<b>Subject:</b>  RATTLE NOISE FROM BOTTOM OF A-PILLAR	<b>Bulletin No:</b> 09-001/14
	<b>Last Issued:</b> 03/28/2014

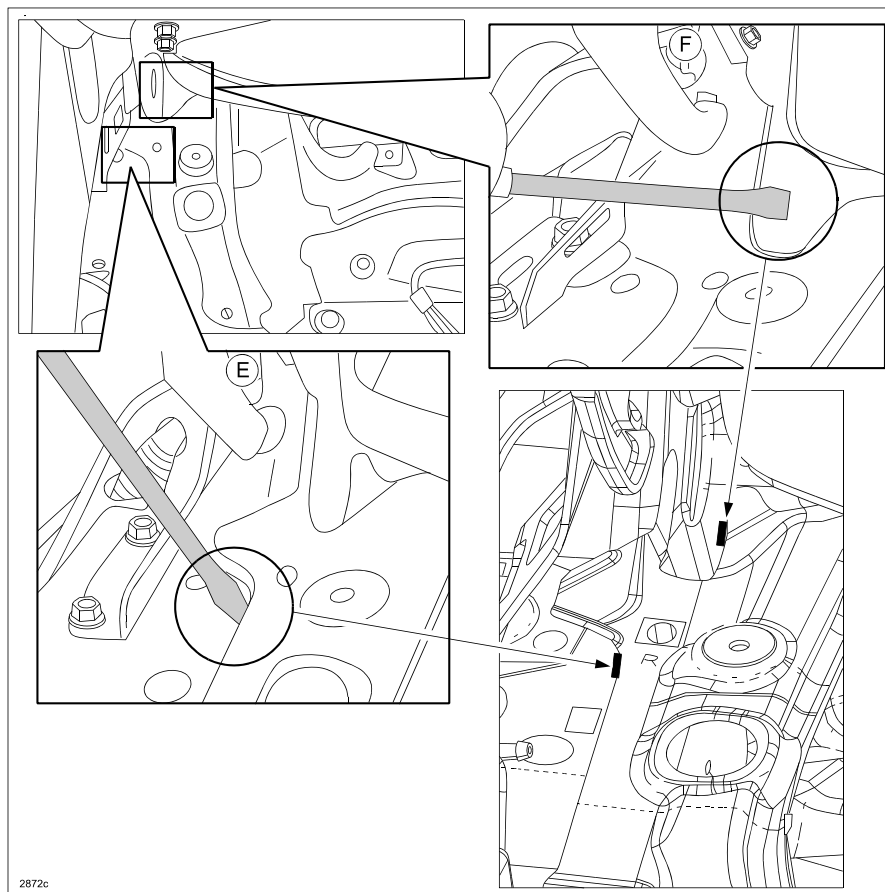
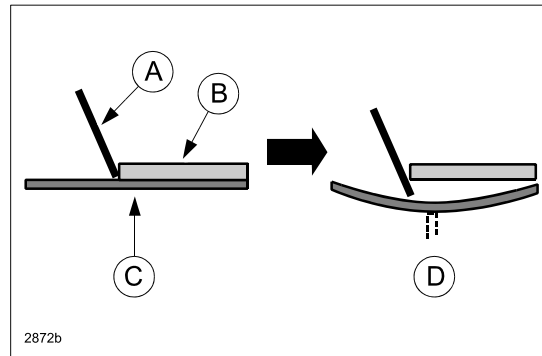
Some vehicles may exhibit a rattle noise from the bottom of the A-pillar when driving on rough roads or over bumps. This is caused by the cowl upper plate and/or dash upper panel interfering with the wiper bracket. To correct the problem, spot welding locations to the dash and cowl assembly have been changed. For the affected vehicles, a clearance needs to be created between the wiper bracket and cowl upper plate and between the wiper bracket and dash upper panel.

- Place the tip of a covered\* flat-blade screwdriver (A) between the two panels (B and C) at the joint (between the wiper bracket and cowl upper plate (E) and between the wiper bracket and dash upper panel (F)) and hit the head of the screwdriver with a hammer to create a clearance of approximately 0.5 mm (D) between the two panels.

**\*NOTE:** To avoid damage to the paint, wrap protective tape around the tip of the screwdriver. If the panels are scratched, apply appropriate corrosion protection primer.
